SUBMITTAL OF HANFORD FACILITY RESOURCE CONSERVATION AND RECOVERY
ACT (RCRA) PERMIT MODIFICATION NOTIFICATION FORM 24590-HLW-PCN-ENV-
06-005

Modification Notification Form 24590-HLW-PCN-ENV-06-005 updates the Process Flow
Diagram (24590-HLW-M5-V17T-P0006) for the High-Level Waste (HLW) Canister
Decontamination Handling System found in Appendix 10.1 of the Reference.

Hanford Facility RCRA Permit Modification Notification
Form 24590-HLW-PCN-ENV-06-005

| BY | DATE | <div style="text-align: center;"> <h1>PROCESS FLOW DIAGRAM</h1> <h2>HLW VITRIFICATION</h2> <h2>HLW CANISTER DECON</h2> <h3>(SYSTEM HDH)</h3> </div> | |

| <input checked="" type="checkbox"/> YES <input type="checkbox"/> NO <input type="checkbox"/> EMBLONS OUT IF YES | | 24590-HLW-M5-V17T-P0006 | |

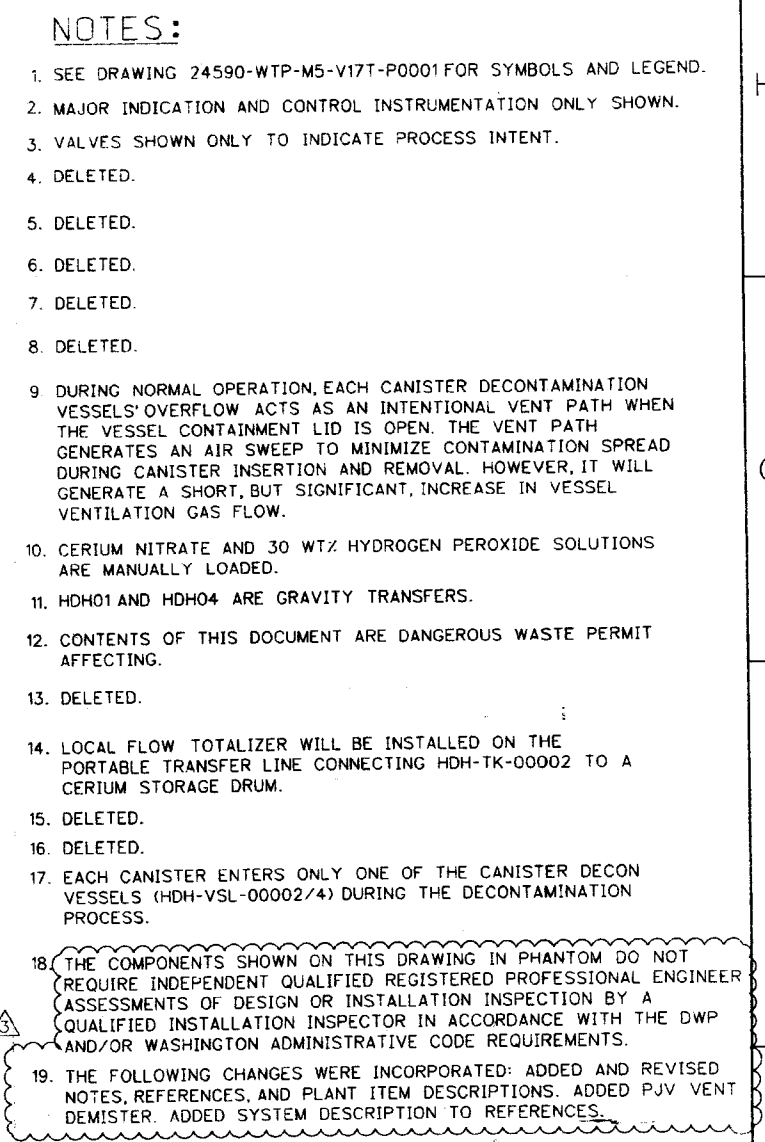
Page 2 of 3: Hanford Facility RCRA Permit, Part III, Operating Unit 10, Waste Treatment and Immobilization Plant
Update HLW Vitrification Building Process Flow Diagram (PFD) for the HLW Canister Decontamination
Handling (HDH) System in Appendix 10.1 of the Dangerous Waste Permit.

| 3 | ISSUED FOR PERMITTING USE, SEE NOTE 19 FOR CHANGES | RR | NJ | JP | JFS | 3-22-05 |
